Recent Questions to PWP on the 2023 Integrated Resource Plan Effort	
Includes questions from the Power IRP Virtual Community Meeting #2 held on April 27, 2023	
1	<p>Question: What are Utility-scale Resources?</p> <p>Response: Utility-scale Resources are energy generation or storage facilities that are considerably larger than typical residential or commercial facilities (typically 1 MW or larger).</p>
2	<p>Question: What are Internal Resources?</p> <p>Response: Internal Resources are facilities that are connected electrically anywhere within PWP's Power System. Such facilities exist on the PWP side of the T.M. Goodrich (TMG) transmission connection - the single point through which all power flows into Pasadena, and are usually, but not always located within city limits.</p> <p>In general, "Internal" refers to PWP's service territory.</p>
3	<p>Question: What are External Resources?</p> <p>Response: External Resources are facilities located outside of PWP's service territory. Any resource that falls on the California Independent System Operator (CAISO) side of TMG (i.e., "the grid") is external. External resources do not necessarily need to be connected to CAISO but must deliver into

Figure 1 | PWP Base, Low, and High Cost Curves for Utility-Scale Solar

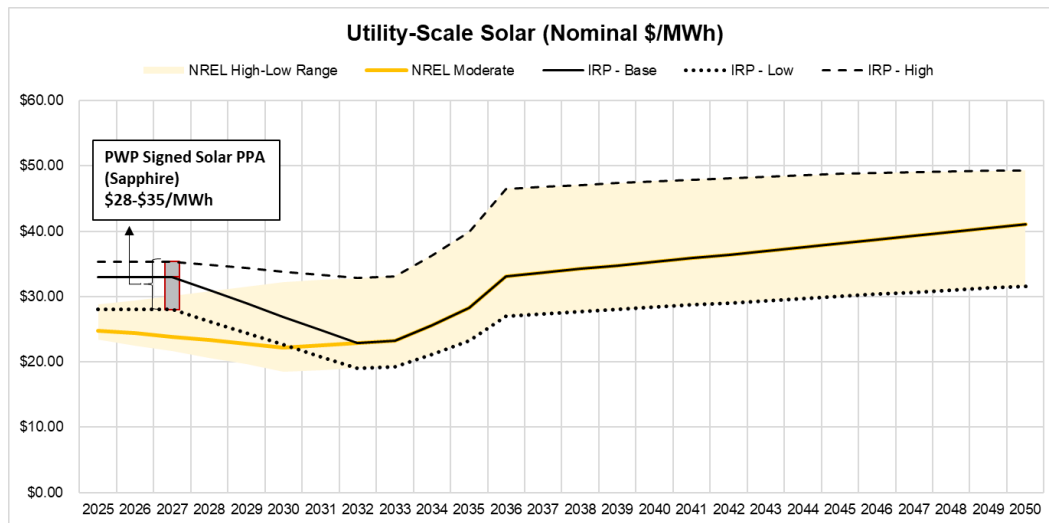
20	<p>Question: Feedback has been received that the forecasted cost of new resource options during the critical period of 2027 to 2032 appears to be inflated by a process of delayed “blending,”</p>

taking the price of a single 2022 contract and blending it into the National Renewable Energy (NREL) benchmark data for a period of 5 to 10 years. The result of the blending is to create an increase in the forecasted cost for renewables until after the 2030 goal. . To select one contract from 2022 and use it as a way to increase NREL’s ATB cost data for a period 5-10 years after the contract seems unreasonable.

The methodology developed by PWP and ACES was intended to use the best available information to develop near-term benchmarks for long-term projections for the cost of new technologies. The EDF Sapphire (Sapphire) project was signed in early 2023 for delivery by December 31, 2026. Sapphire provides a real project model with pricing that PWP can use to benchmark cost in 2026 and 2027.

In multiple publications, NREL has repeated the statement that its cost curves do not reflect current market conditions. Therefore, it is not a reliable source of actual cost information in the near-term. Figure 1 below shows the Sapphire price range compared the nominal Levelized Cost of Energy (LCOE) calculations using NREL capital cost data. Using NREL capital costs would drastically understate the actual cost of procuring solar in this market environment.
